RESPONSE TO WORKING GROUP AND PUBLIC
COMMENTS ON THE SITE C CLEAN ENERGY
PROJECT ENVIRONMENTAL IMPACT STATEMENT

Technical Memo

PEACE ATHABASCA DELTA

MAY 8, 2013

Figure 3 Duration Curves of Simulated Flow/ Water Level at Peace Point With and Without Site C

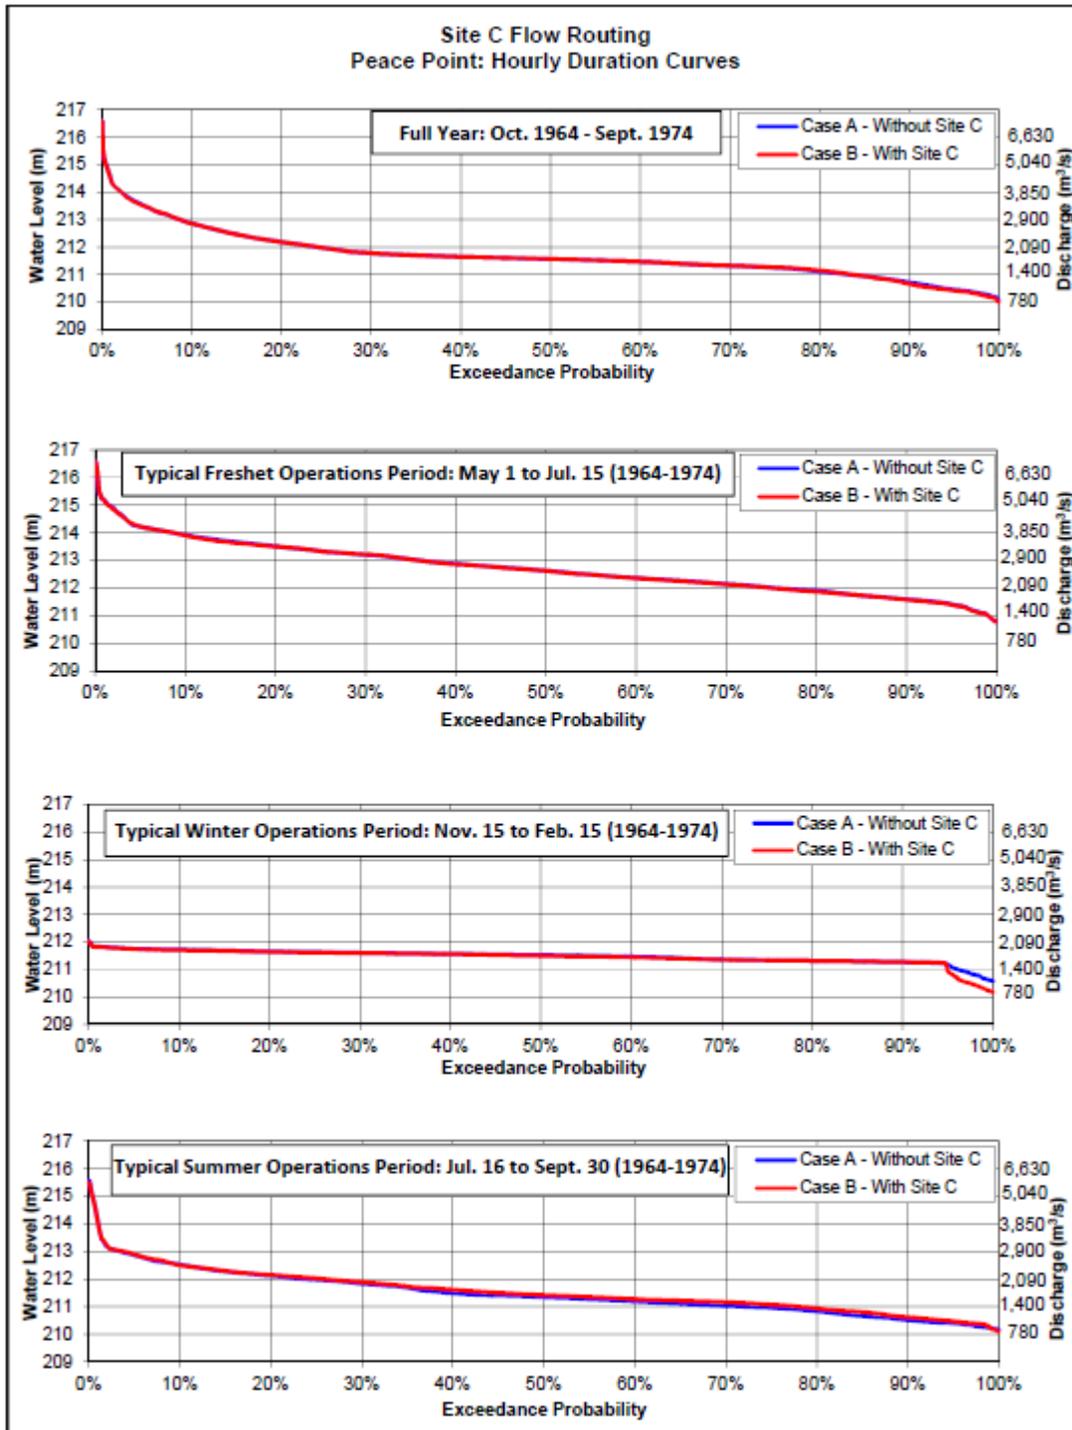
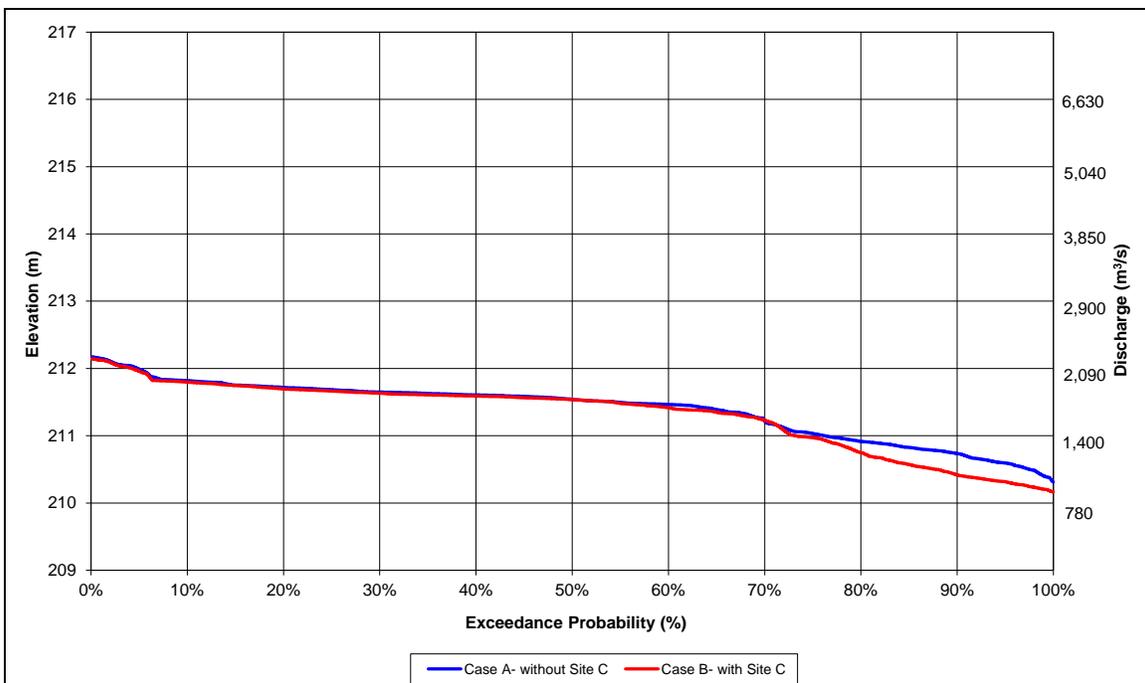
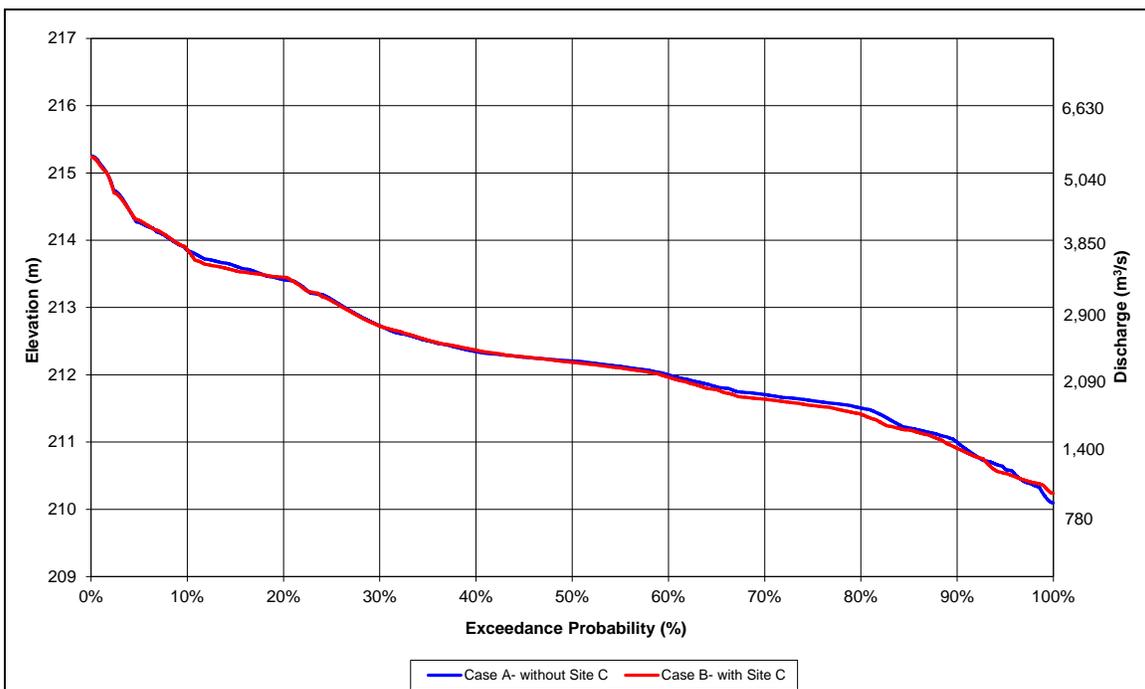
- 1) The scope of the assessment should extend to the PAD due to potential alterations in ice formation, ice break up/jamming and flood regime
- 2) The scope of the cumulative effects assessment should extend to the PAD
- 3) The Project could have an effect on the exercise of treaty rights and other traditional use of the PAD by Aboriginal peoples
- 4) The PAD should be a valued component

At Peace Point (the downstream extent of the surface water regime study, located approximately 40 km upstream of the PAD), negligible change in surface water regime is predicted as a result of the Project compared to the natural variability of the surface water regime at that location. This assertion is further explained in the Spatial Boundary Selection Technical Memo. Annual and seasonal duration curves of hourly flow/ water level with and without the Project were provided in the EIS and are attached for reference (see Figure 3). Additional duration curves of hourly flow at Peace Point for the ice freeze-up and break-up periods (taken as the month of November for freeze-up and the period April 15 to May 15 for break-up) are also attached to better illustrate the predicted influence of the Project during those particular periods (see Figures 4 and 5).

At Peace Point, the downstream extent of the hydraulic model (approximately 1,030 km downstream of the Site C dam site), Figures 3, 4 and 5 illustrate that the duration of any particular flow/water level both with and without the Project are very similar. The only notable predicted change is a small increase in the frequency of low flows with the Project in the typical freeze-up period. The possibility of a relationship between the freeze-up stage (water level) and the probability of dynamic break-up and ice-jams in the spring has been researched¹². The probability of ice jamming would not be influenced by the relatively lower flows that are predicted to occur periodically during the freeze-up period with the Project. Ice cover that forms at a low level during a period of relatively low flow in November would re-freeze at a higher level as flows increase in December. The change in freeze up levels occurs because with increasing flows, the floating portion of the ice cover in the main channel releases from the border ice attached to the banks, floats up to accommodate a higher flow beneath it, and re-freezes to the banks at a new, higher freeze-in level¹³. Consequently, the predicted small increase in the frequency of lower flows in November would not effect the frequency of ice-jams in the lower reaches of the Peace River. The timing and magnitude of ice-jamming would also not be influenced by the Project.
